Channel Stability Problems, Pajaro River, Watsonville and Pajaro, California

**U.S. Army Engineer Committee on Channel
Stabilization Report of the 63rd Meeting**

ERDC/CHL SR-00-3
CCS-00-1
August 2000

Figure 5. Location map

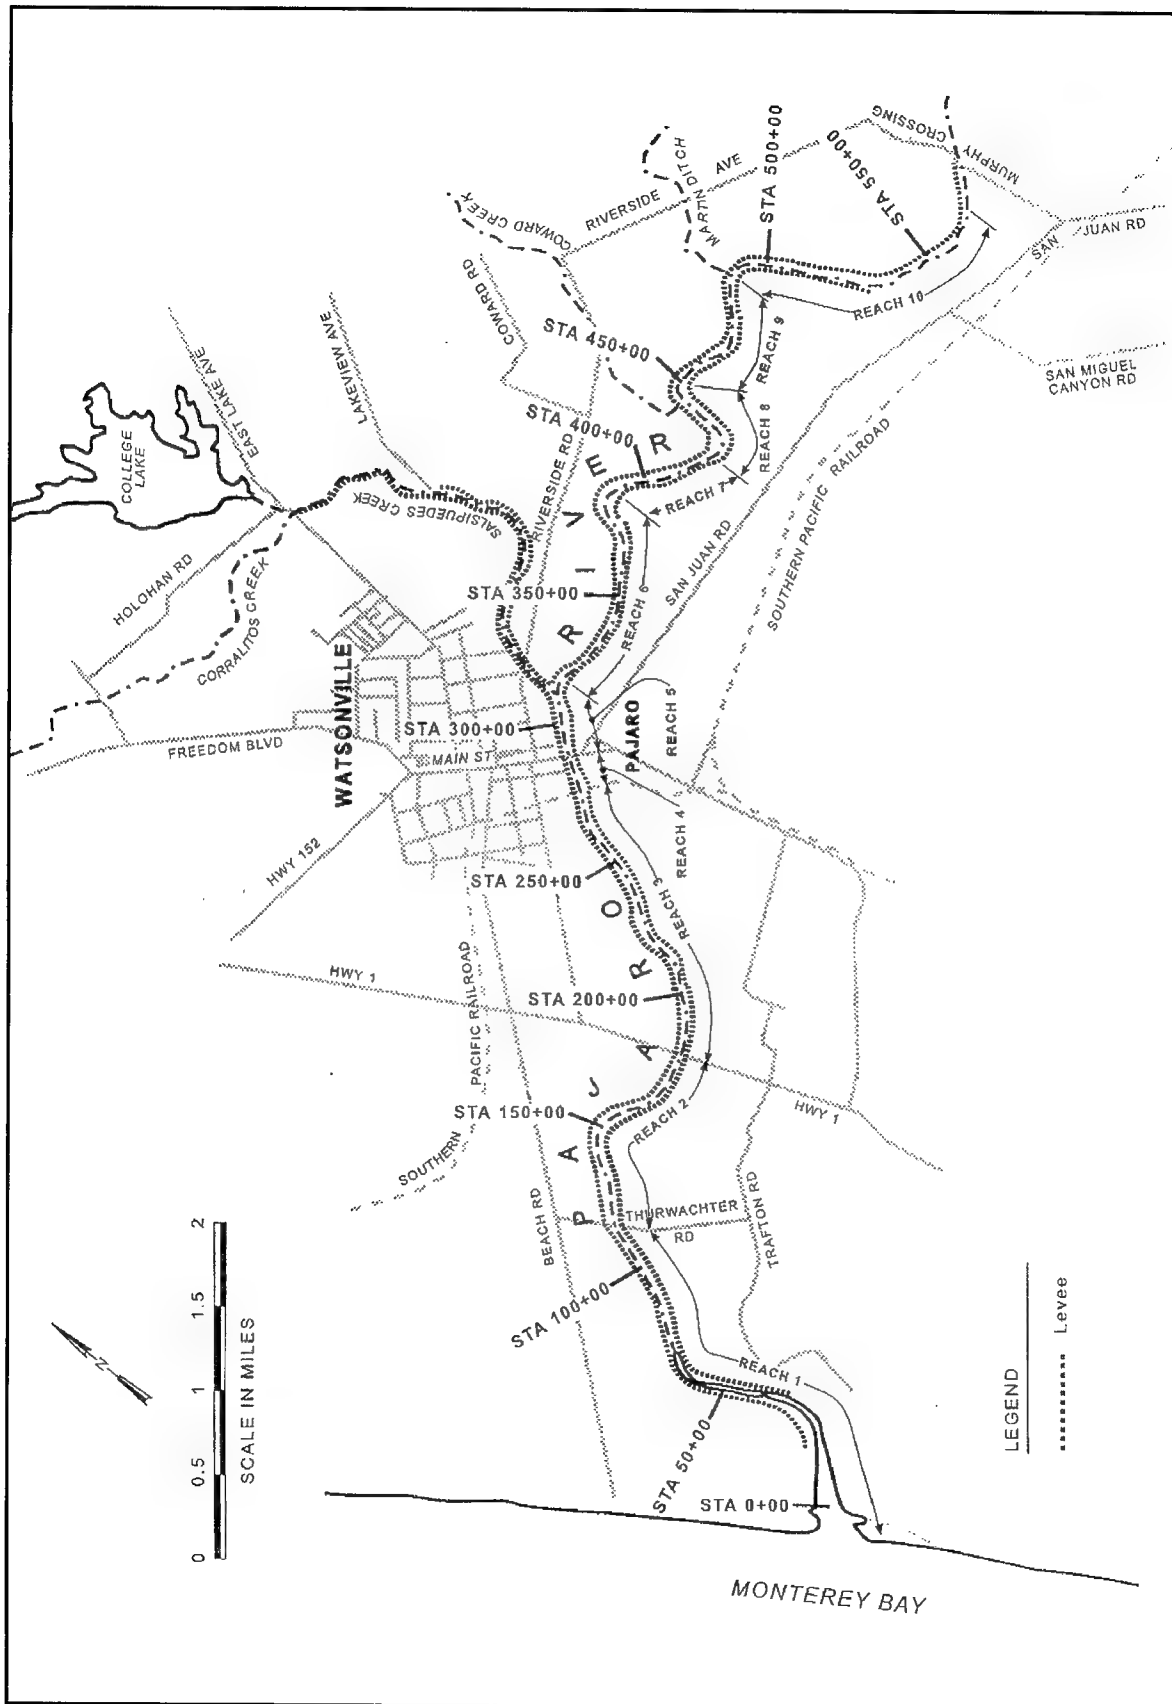
- a. Based upon the information provided in the pre-inspection briefing and field observations, it would appear that the high banks have eroded past the “original” high bank in a relatively few locations. (Figure 5) these are: (1) Sta 132+00 to 142+00 RB; (2) Sta 164+00 to 166+00 LB; (3) Sta 176+00 to 178+00 LB; (4) Sta 219+00 to 224+00 RB; (5) Sta 243+00 to 247+00 LB; (6) Sta 275+00 to 276+00 LB; (7) Sta 296+00 to 297+00 LB; (8) Sta 323+00 to 324+00 LB; (9) Sta 333+00 to 345+00 LB; (10) Sta 374+00 to 376+00 RB; (11) Sta 415+00 to 417+00 LB; (12) Sta 422+00 to 423+00 LB.

Figure 6. Incorrect installation of erosion control mats

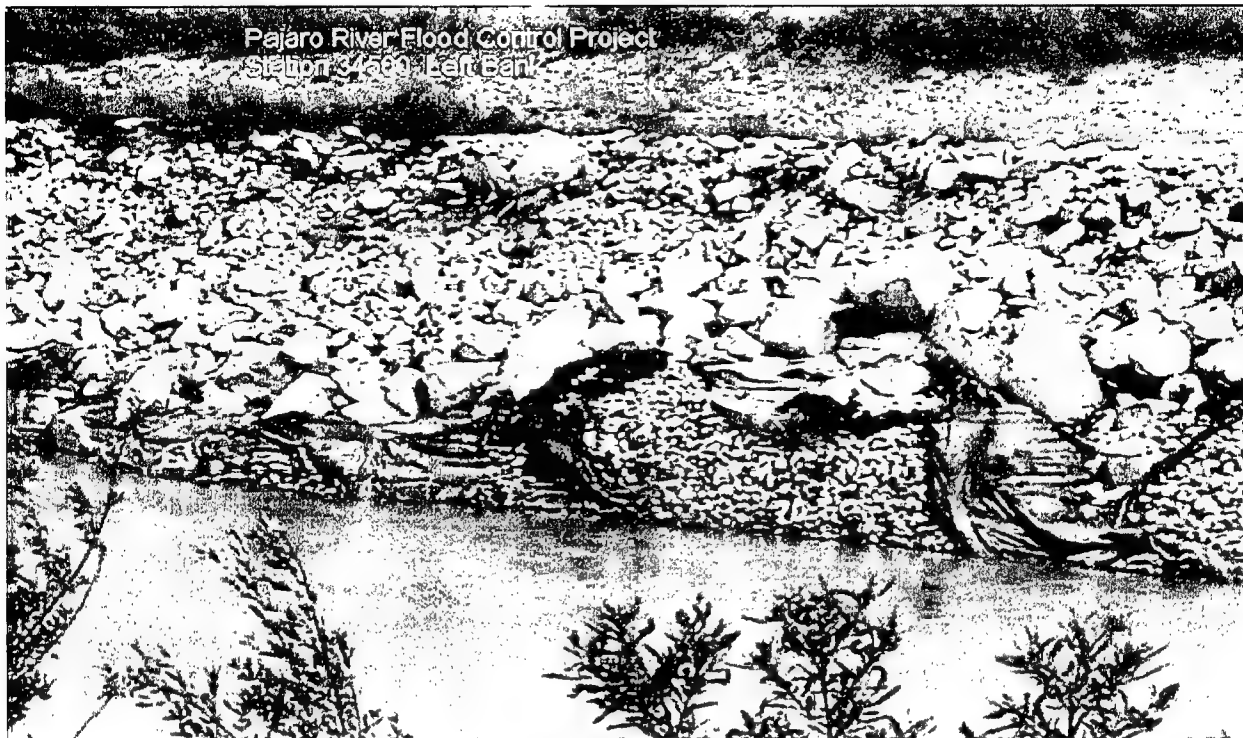
- c. The locations where the banks have been stabilized are very steep. Also, the stone, although apparently well graded, is inconsistent in size. The erosion control mats have been installed incorrectly and/or have been applied to situations for which they were not intended (see Figure 6).

Figure 7. Alternative 1a

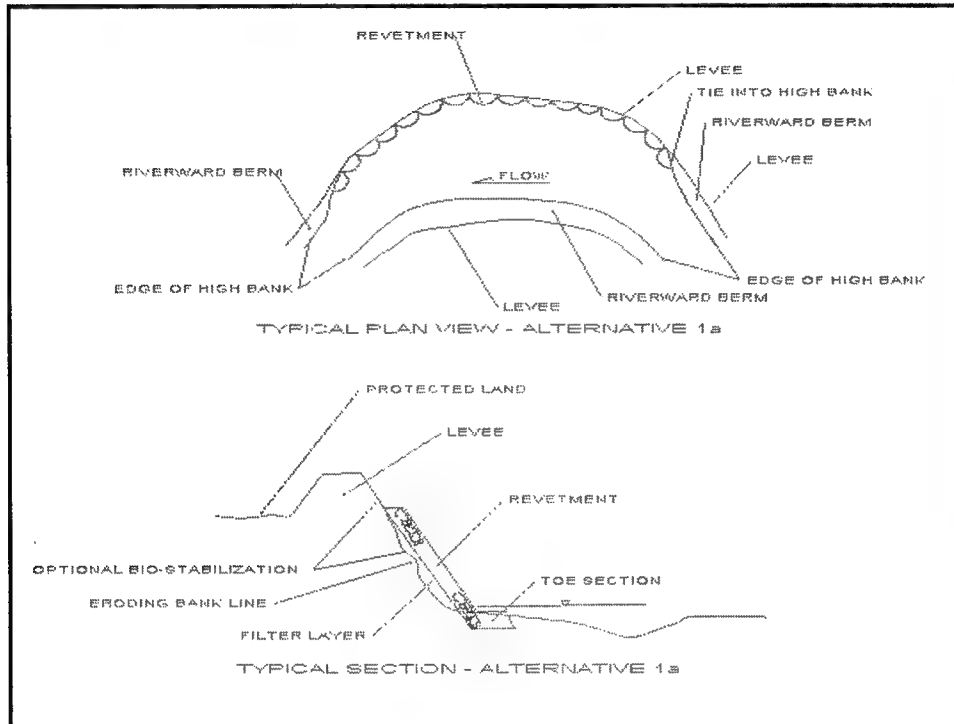
The Committee looked at two different scenarios for bank stabilization: first, where the bank has eroded up to the toe of the levee (within 10 ft); and second, where the bank has eroded to within 30 ft of the levee toe. For the first case the Committee developed three alternatives for stabilizing the banks (Figures 7 and 8). Alternatives for the second case are shown in Figure 9.

- a. Of the alternatives for stabilizing the banks that have eroded to the toe of the levee, Alternative 1b (peak stone revetment with horizontal tie backs) is my recommended plan. This alternative will provide protection for the toe of the bank without promoting excessive deposition. However, there are risks associated with leaving a vertical bank adjacent to a levee. These risks included subsequent geotechnical failures, continued erosion during prolonged high-flow events, and decreased seepage paths. To counter some of these impacts, biostabilization could be employed above the horizontal tiebacks, or every second or third tieback could be a sloping tieback. The tiebacks should be perpendicular to the peak stone revetment, and should be spaced at 100-250-ft intervals depending on the degree of curvature in the bend. The tighter the bend the closer the spacing.
